## CITY OF ALBUQUERQUE

Site: Rohan Subdivision

Drainage Ordinance (14-5-2-1) Violations for Erosion and Sediment Control Re:

No stabilized Construction Entrance/track-out pad.

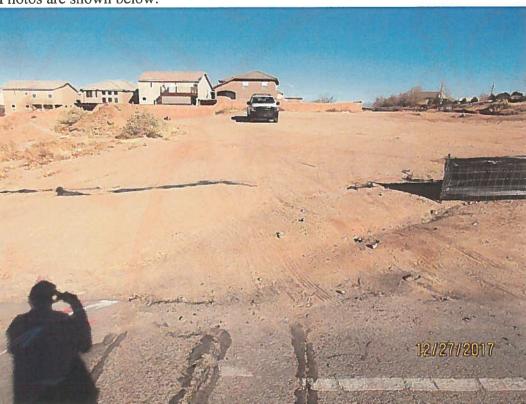
- 1. There was no stabilized construction entrance/track-out pad.
- 2. The silt fence did not extend fully across the western edge of the project.
- 3. The silt fence was not buried. Silt fence does not work if it is not buried.

1. Install a stabilized construction entrance/track-out pad per the approved Erosion and Sediment Control plan.

View from edge of arroyo.

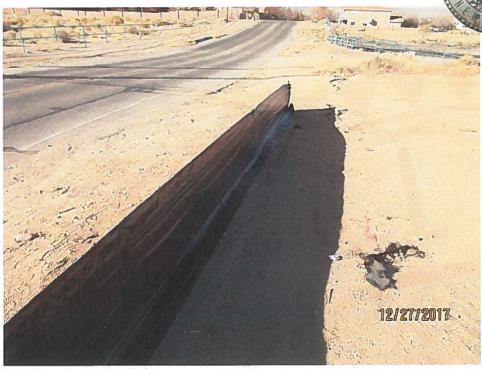
Silt fence does not extend across western edge of disturbed area.

Silt fence is not buried.

2. Install silt fence/sediment BMP (e.g filter sock) across the western edge of the disturbed area; including Lot 9C which has become part of the grading of the site. Silt fence/sediment BMP is to have a terminus at the Eagle Rock Rd ROW.

3. Bury the silt fence per the approved Erosion and Sediment Control plan.
